HASTINGS PLANNING COMMISSION A G E N D A

Monday May 4, 2026

Subject: North Ridge Estates Condominiums PUD
[Newly named Thornapple Meadows
Condominiums]

Request: *Special Use Permit/Site Plan Review –
Pennock Gardens*

THORNAPPLE MEADOWS CONDOMINIUMS SITE PLAN HASTINGS, MI

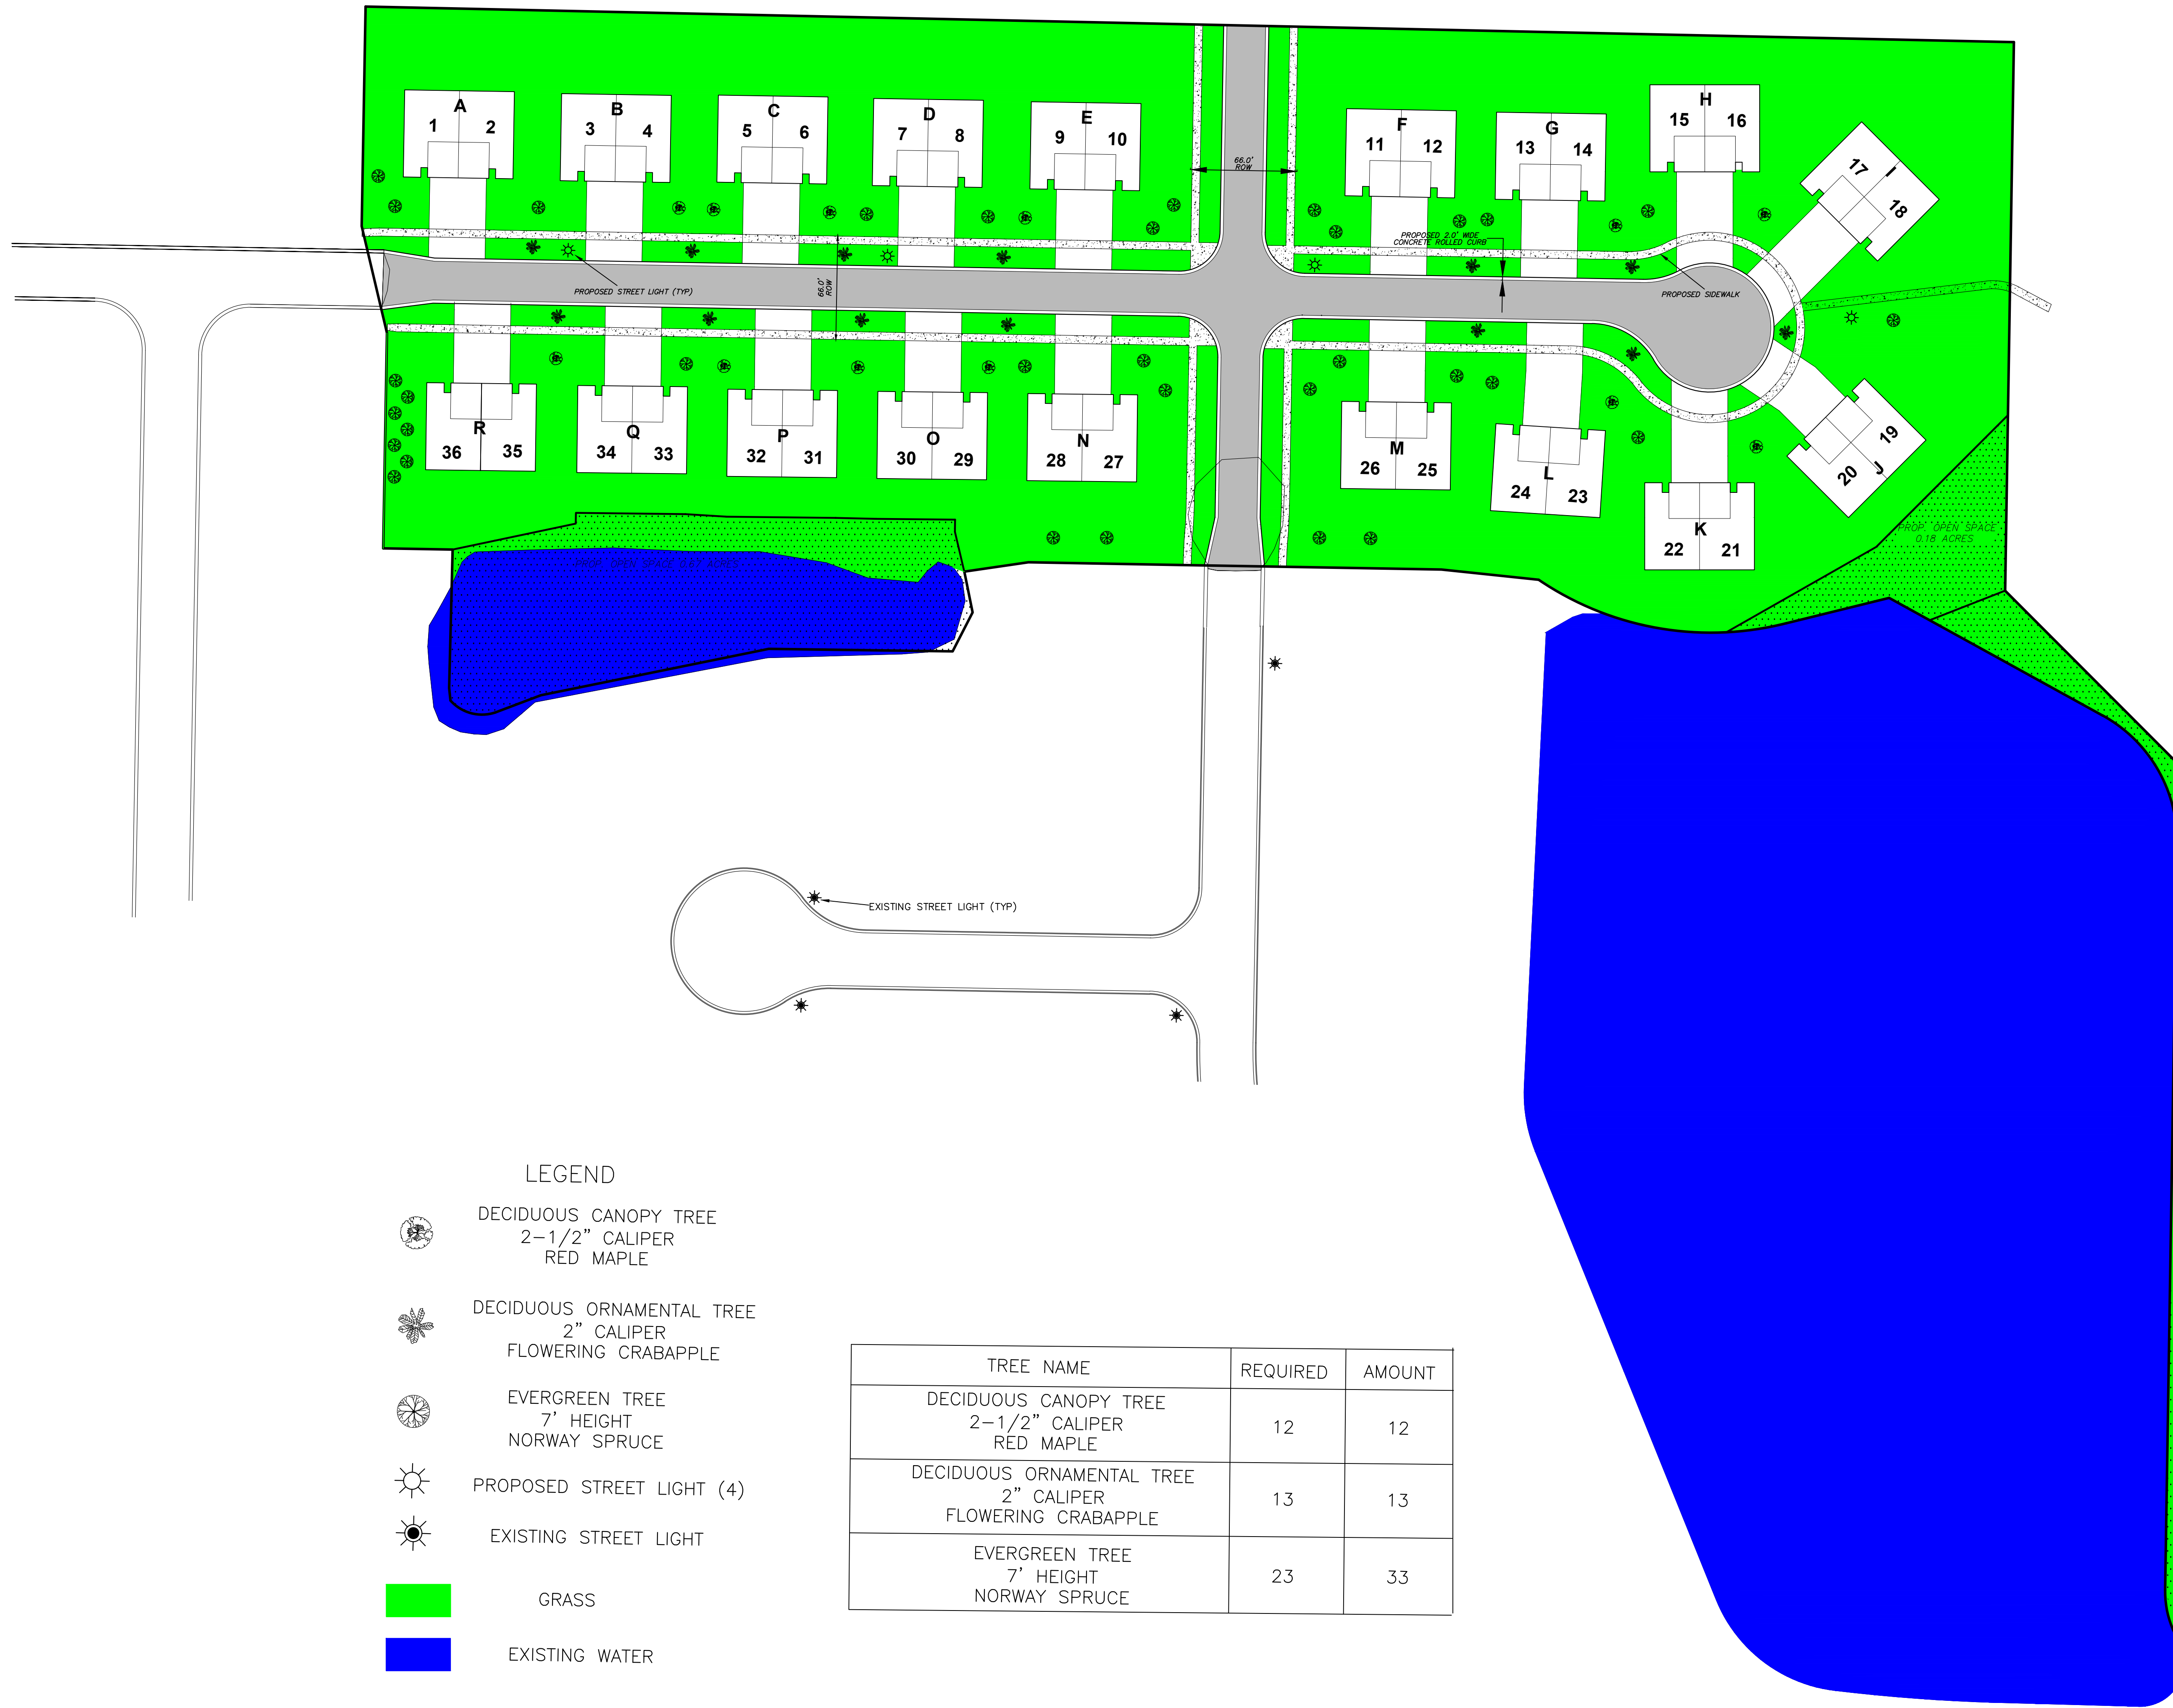
6. The location, description, use/occupancy and maintenance provisions for all general and limited common elements shall be provided in the master deed for the project and shall be subject to City review/approval. – **compliance cannot be confirmed**

7. The development will adhere to the 10% Open Space minimum requirement. – **the proposed open space has been reduced from 0.94 acres (11.74%) to 0.85 acres (10%) and consists entirely of drainage basins**

**THORNAPPLE MEADOWS
 CONDOMINIUMS
 LANDSCAPING PLAN**
 HASTINGS, MI

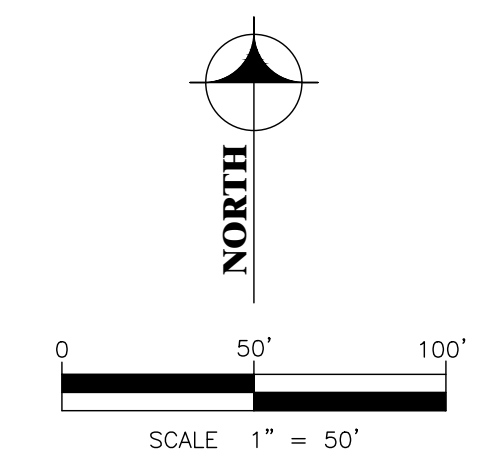
- The Landscape Plan has been modified to reflect the reduced open space area and compliance with the Front Yard Landscaping Requirements (Sec 90-1101). – **required shrub plantings have not been indicated**

Layout Plan

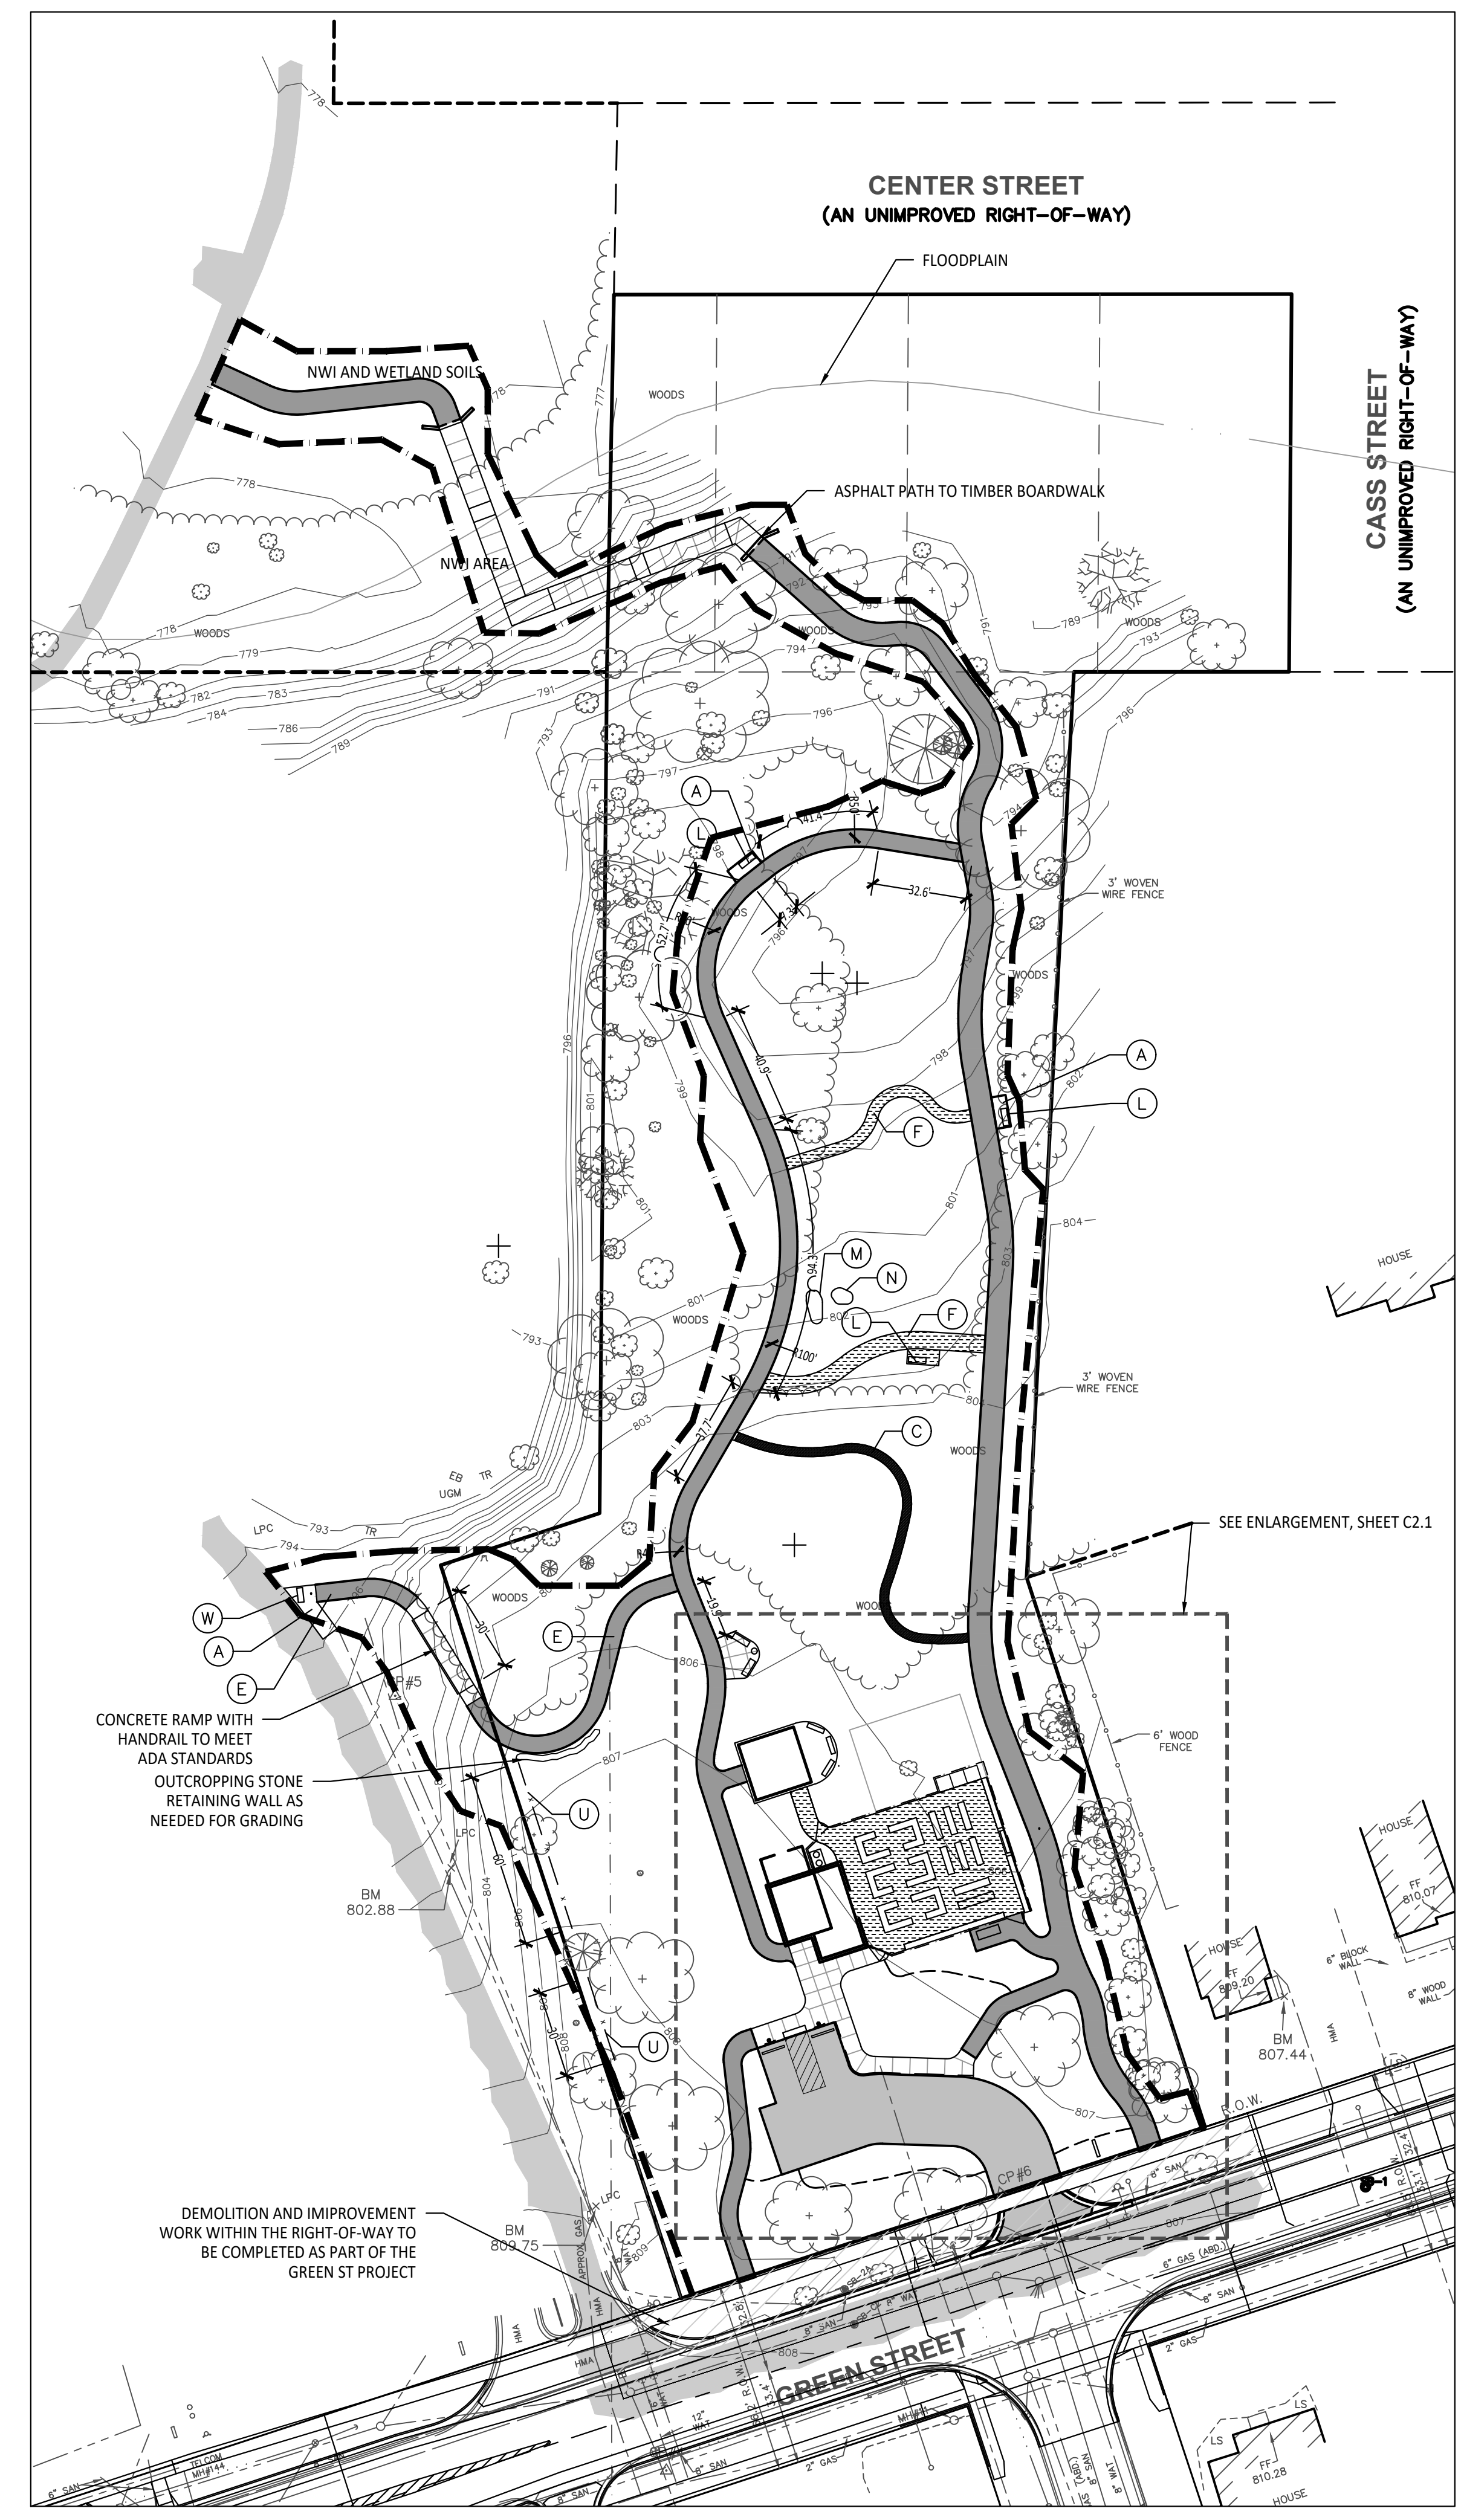
- A 24 ft wide driveway is proposed only to serve two (2) on-site barrier free parking spaces.
 - The proposed driveway is located opposite the intersection of Cass Street, as recommended.
 - The proposed driveway is provided a 100-150 ft separation from adjacent driveways, as recommended.

- **Approval should be subject to a driveway permit from the City of Hastings.**
